Access Compliance Report

Public Rights-of-Way

Intersection ID: 20326	Main Street: MONTPELIER_RD	Cross Street: WEDGEDALE_DR	Location: W
ADA ID: DF26CE8DC8A9	Ramp Type: BlendTrans2	Initial Pass/Fail: Pass	Overall Compliance: No
Severity Score: 2.75			
Codes/Mitigation Info/Possible Solution		Field Measurements/Component Compliance

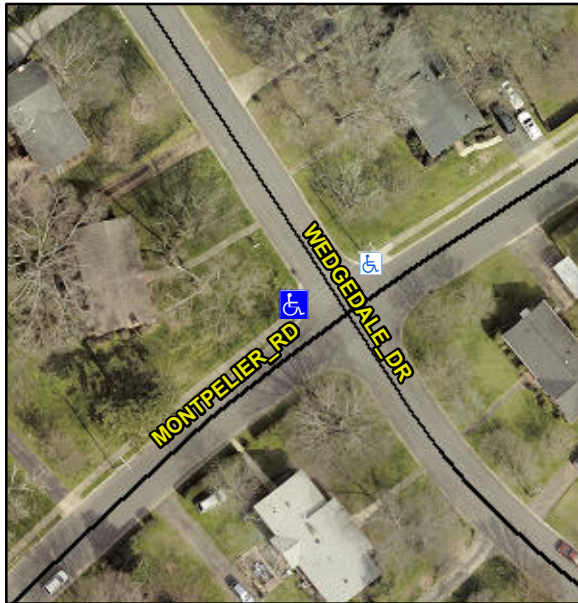
CURB LIP 1.0

Not Found, R304.5.3, R305.1.4, R305.2

Remove & Replace Curb Ramp With Two New Directional Ramps or Equivalent. Remove & Replace Gutter.
